MEMORANDUM

From: Stephen Chiles, Chiles Ltd
To: Pam Butler, KiwiRail
Date: 12 February 2021
Subject: KiwiRail Regional Freight Hub -
Response to requests for information relating to noise and vibration

Palmerston North City Council has requested further information relating to KiwiRail's Notice of Requirement for the proposed Regional Freight Hub (PNCC letter dated 14 December 2020). Items 7 to 31 of the request for information relate to noise and vibration. Responses to those items are provided in this memo. For each item the request is written in italics followed by the response. Several responses refer to a set of 17 figures that are attached to this memo.

Drawn: MS
 Date: 27 Jan 2021

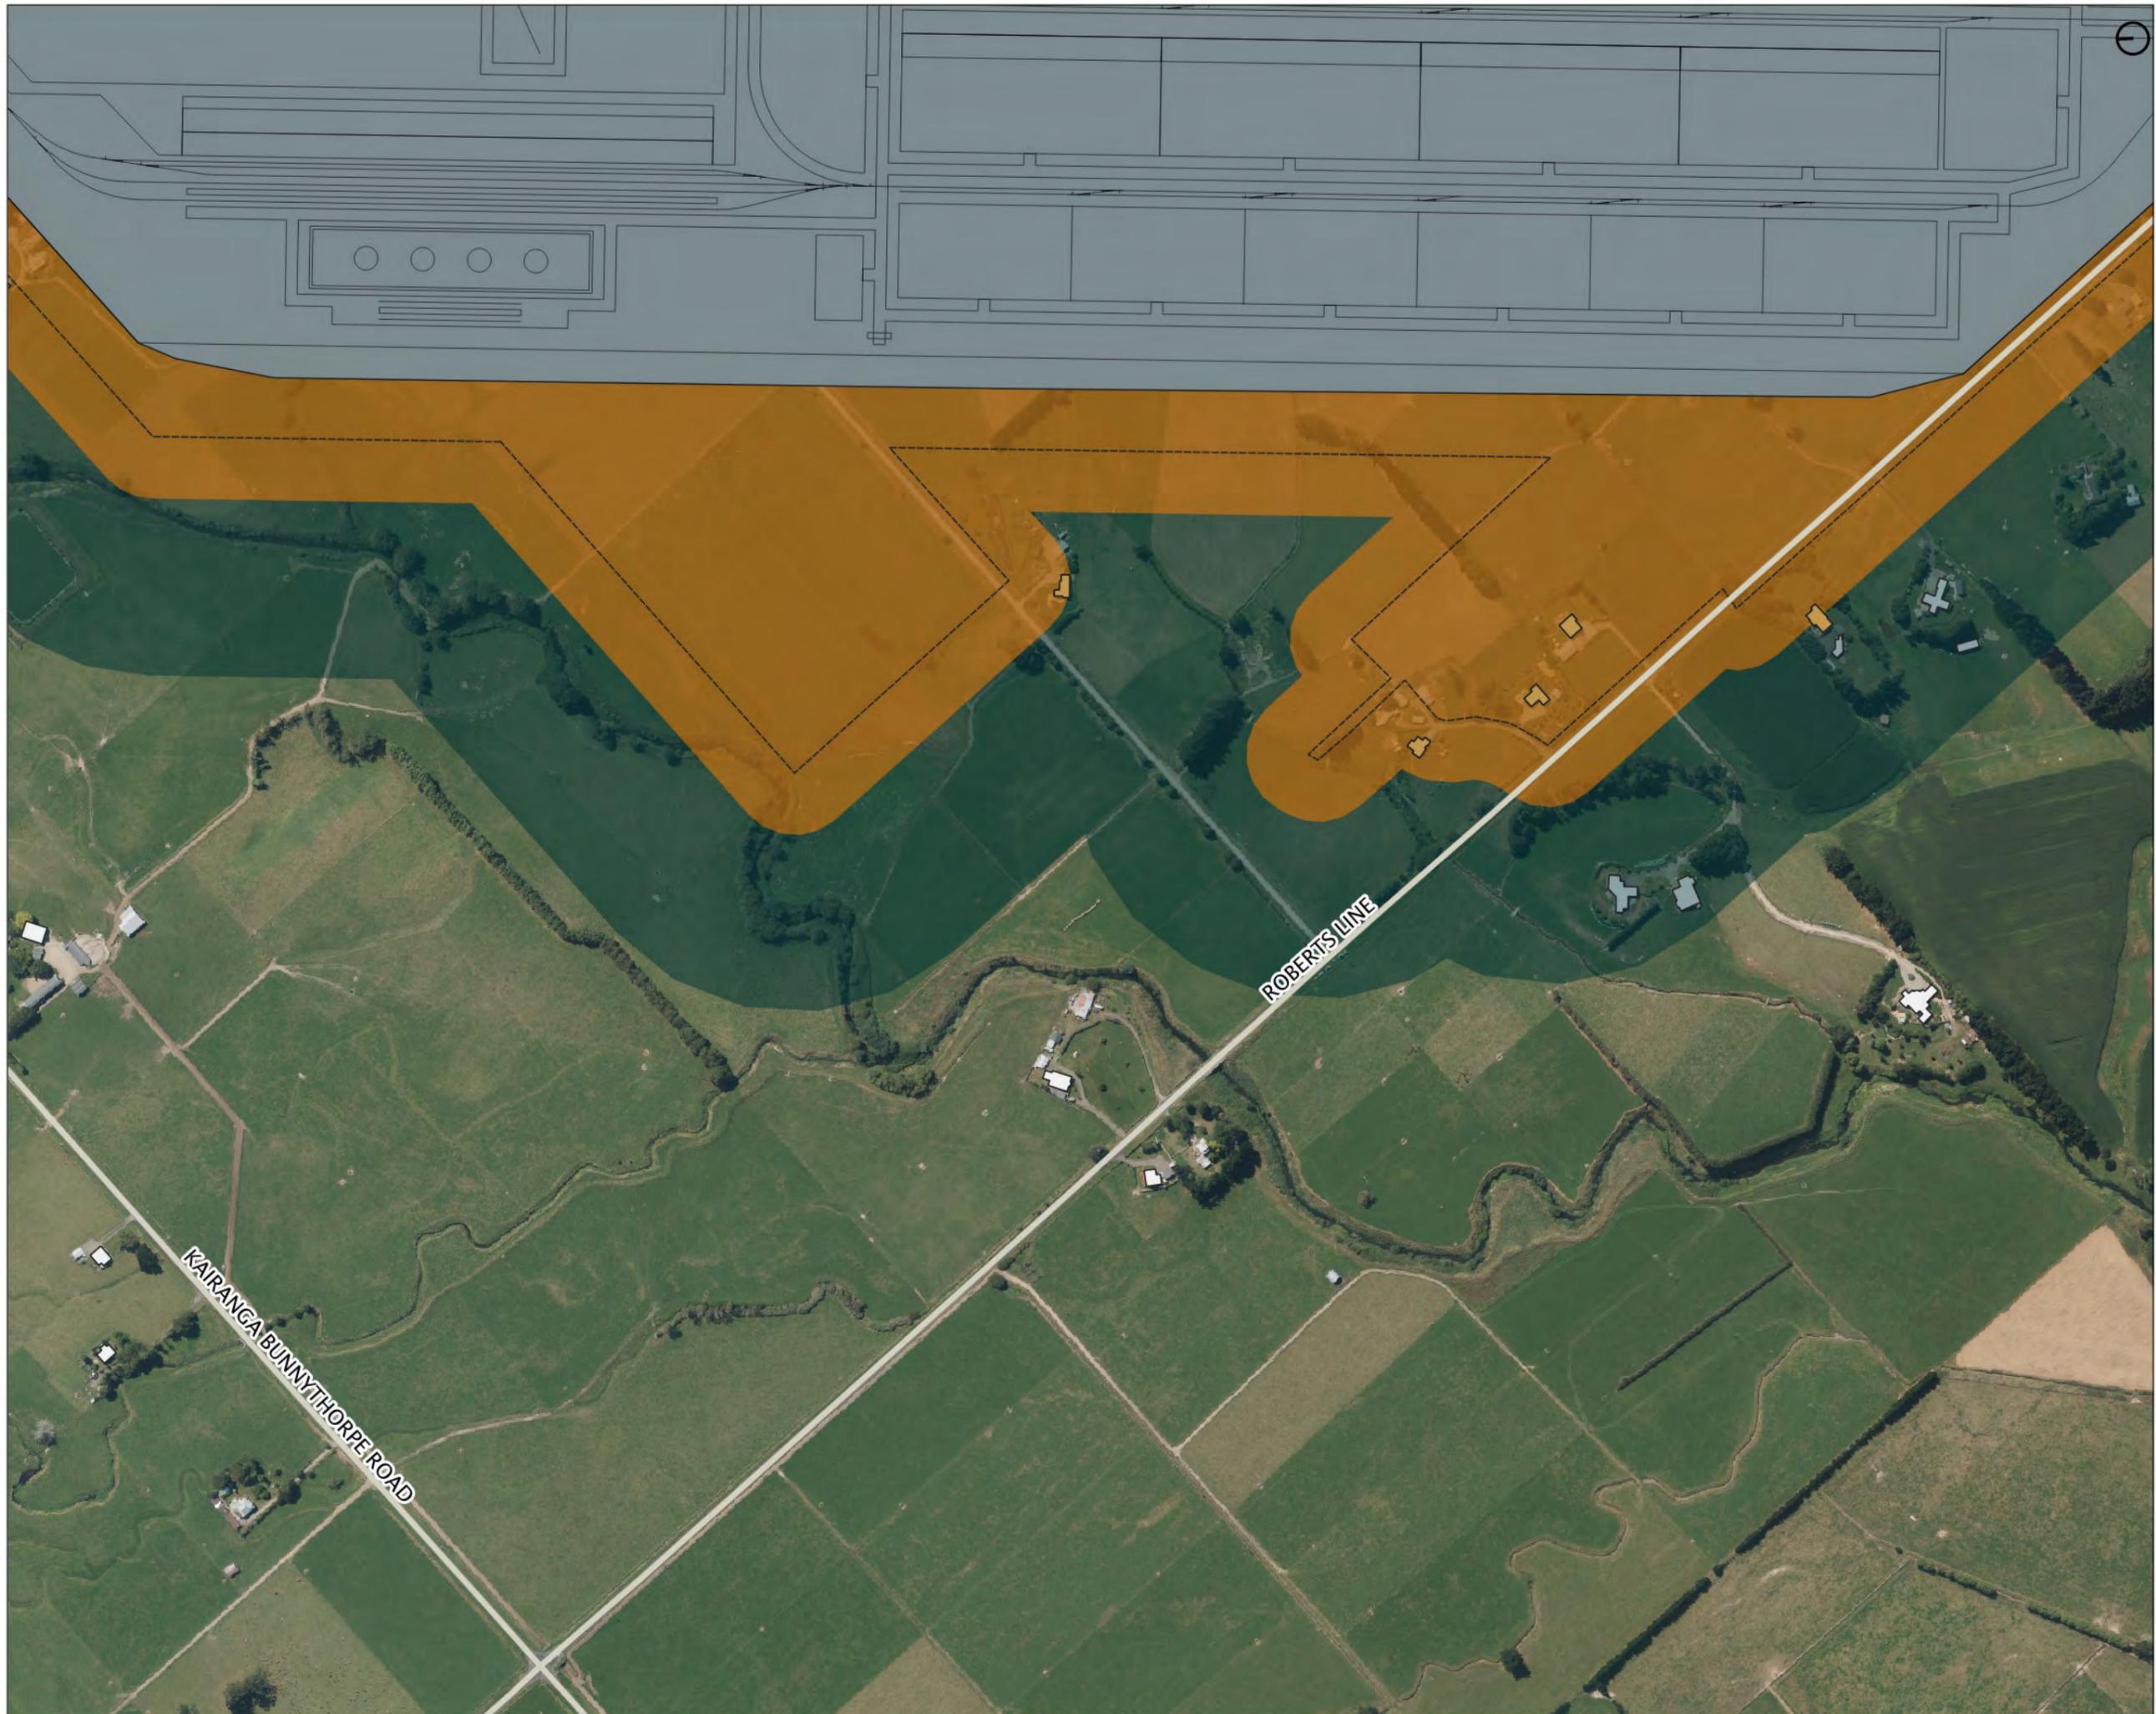
Please provide the addresses of dwellings or groups of dwellings within the 50 metre and 200 metre buffers illustrated in Figure 11 of the Acoustic Assessment for construction noise impacts.

The relevant addresses can be identified using the data contained at Figure 11 of Technical Report D. To aid reading of Technical Report D Figure 11 (page 33) the data has been reproduced at a larger scale in the attached Figures 12 to 17.
